## TECHNICAL MEMORANDUM

Re: **RI Phase 3 Modification No. 6  
Nevada Environmental Response Trust Site  
Henderson, Nevada  
Ramboll Project No. 1690011200-050**

Figure 1 AECOM Downgradient Investigation Monitoring Well Installation Locations

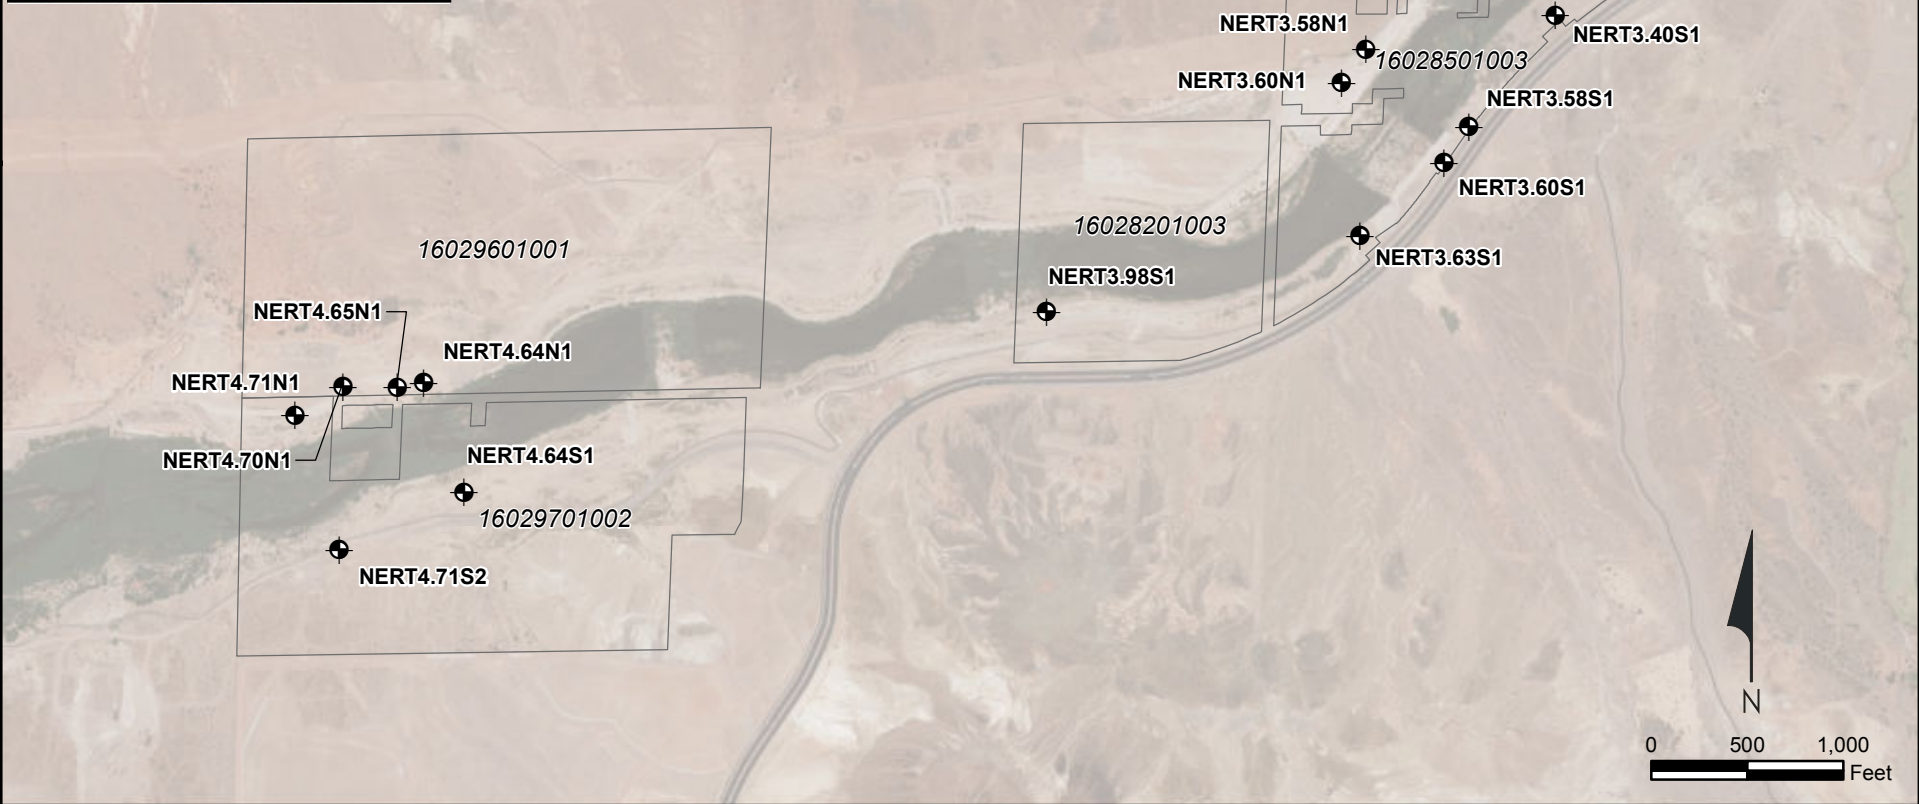
Phase 3 Modification No. 6 will include the drilling of 14 soil borings along the LVW for the purposes of collecting soil samples for laboratory analyses and the installation of 14 4-inch diameter groundwater monitoring wells (primary wells, see Figure 1). The soil borings/wells will be located within previously approved parcel boundaries in the Revocable Permit for Occupancy of Clark County Owned Property by the Nevada Environmental Response Trust dated May 15, 2018 ("Revocable Permit"). The affected Clark County Assessor's Parcel Nos. and the primary wells associated with each parcel are:

- 160-29-601-001 (wells NERT4.65N1, NERT4.64N1, and NERT4.70N1);
- 160-29-701-002 (wells NERT4.71N1, NERT4.71S2, and NERT4.64S1);

- 160-28-201-003 (well NERT3.98S1); and
- 160-28-501-003 (wells NERT3.63S1, NERT3.60S1, NERT3.58S1, NERT3.40S1, NERT3.35S1, NERT3.60N1, and NERT3.58N1).

Additionally, 12 2-inch diameter observation wells will be installed to be used to monitor water levels during planned aquifer pumping tests to be conducted by AECOM; four each centered around the previously identified primary wells NERT4.64S1, NERT3.60S1, and NERT3.58S1. The observation wells will be labeled OW4.64S1-A, B, C, D; OW3.60S1-A, B, C, D; and OW3.58S1-A, B, C, D. The locations of the observation wells are anticipated to be within 30 feet of their associated primary wells, but the precise locations will be selected by AECOM after initial permeability testing of the primary wells.
